Canning Bridge Activity Centre Plan

Background Information and Proposed Amendment Wording - August 2018

Building Heights – Proposals to Include Roof Structures Within Height Calculation:

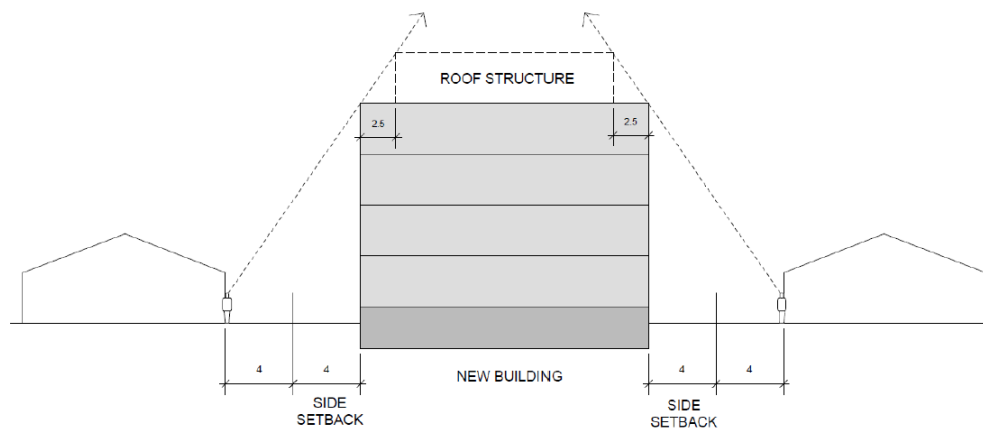
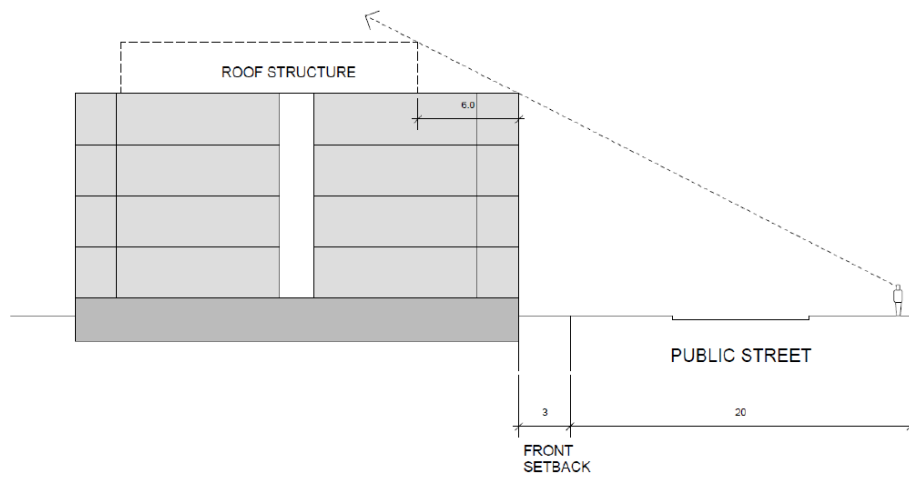
Purpose of Existing Controls	Issues Prompting Proposed Changes	Comment on proposed changes/options
<ul style="list-style-type: none">• Roof gardens and terraces provide opportunities for recreation space and landscaping for resident use.• Roof gardens facilitate water capture and reduce heat island effects.• Structures within roof top recreation areas improve the useability of the spaces.• The four storey, 16 metre height limit is aimed at encouraging generous (high amenity) floor to ceiling heights.	<ul style="list-style-type: none">• Roof top structures are adding to building bulk/height.• Use of roof top structures may contribute to issues with noise and privacy/overlooking.	<ul style="list-style-type: none">• Including roof top structures within the 16m height limit would constrain opportunities for roof top gardens and/or reduce their usability (in four storey developments).• Where roof top structures are provided, within the 16m height limit, there would be need to reduce the floor to ceiling heights within the building (in four storey developments), potentially reducing resident amenity.• Recognised that there is a need to manage the extent of roof top structures to limit issues relating to bulk and privacy/noise.

Amend definition of Height

- 1) In metres:
In relation to a building, means the distance measured from the mean natural level of that part of the land on which the building is erected to the highest point of any part of the building above it but does not include:
 - (a) Any lift plant, water tower or similar utility services, not exceeding 3.0 metres in height; or
 - (b) Any architectural feature or decoration, other than a free-standing sign, not used for any form of accommodation, or any open roofed structures which (in Q1 and Q2 is required to be) is open on three sides and does not exceed 3.0 metres in height, which may be developed to provide recreation and open space opportunities for building occupants which may be approved by the decision maker.
- 2) In storeys:
Does not include a basement.

Cross section of proposed setbacks to roof structures:

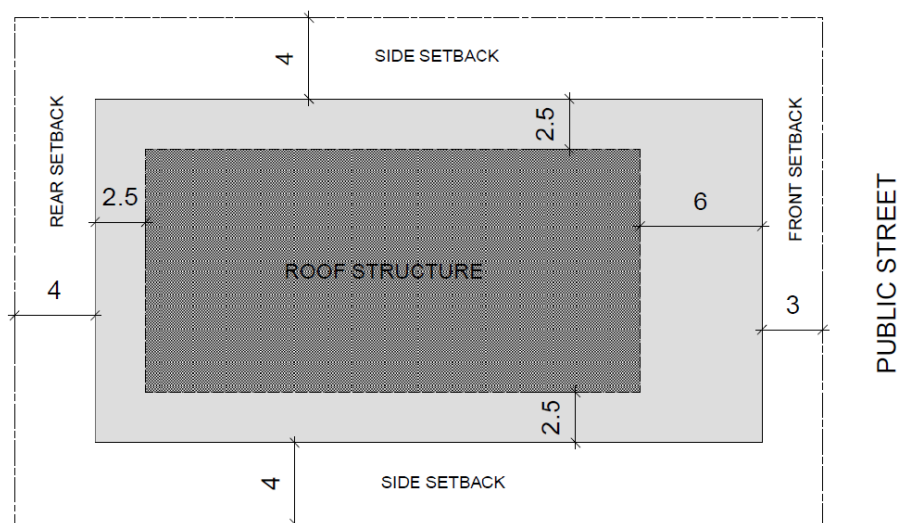
It is proposed that the impact of roof structures be managed through the following measures:

- Roof structure height limit of 3m
- Clarification that roof structures are to be open on at least three sides
- Structures to be setback 6m from building edge at street boundary and 2.5m from building edge for side and rear boundaries.
- The design of roof structures and spaces being subject to privacy provisions of Design WA (accessible roof spaces being designed, screened or setback to ensure compliance with privacy requirements).

Add a new clause 4.9 on page 29

Within H4 Zones (in Q1 and Q2) any structure located at roof level containing a roof and wall(s) shall be setback from the front street boundary an additional setback distance of 6 metres from the building edge

Add a new clause 5.8 to page 30

Within H4 Zones (in Q1 and Q2) any structure located at roof level containing a roof and walls shall be setback from side and rear boundaries an additional setback distance of 2.5 metres from the building edge.

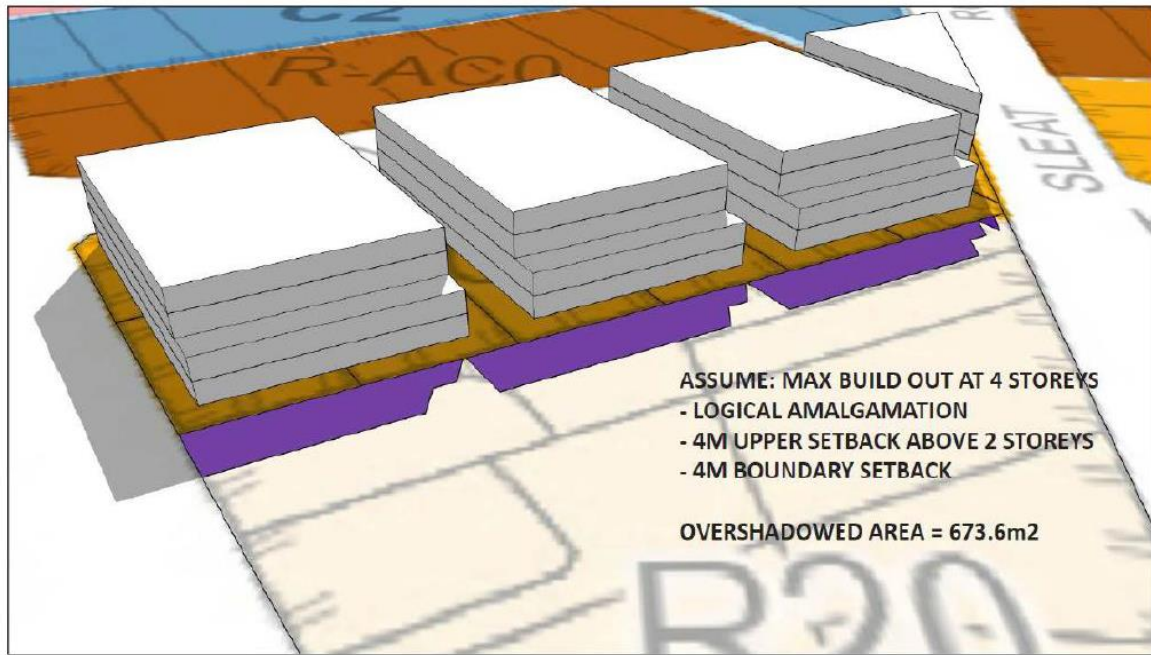
Shadow diagram analysis has been used to determine how far a three or four storey development would need to be setback from an adjoining property to reduce impacts of bulk and shade to that of a more typical two storey development. Investigations indicate that an eight metres setback to third and fourth storeys from side or rear boundaries would provide a significant reduction in impacts of bulk and shade. That is for sites on the perimeter of the CBACP area, adjoining land outside the Plan area, development would be required to be setback four metres for the first two levels (or greater setback if required by privacy controls), with any third or fourth storey being stepped back further to achieve an overall setback of eight metres. Introduction of this requirement is proposed.

New clause 5.8

- 5.8 Development of any third or fourth storey on any site (in Q1 and Q2) adjoining residential zoned land outside of the Canning Bridge Activity Centre Plan shall be setback a minimum of 8 metres from that common boundary.
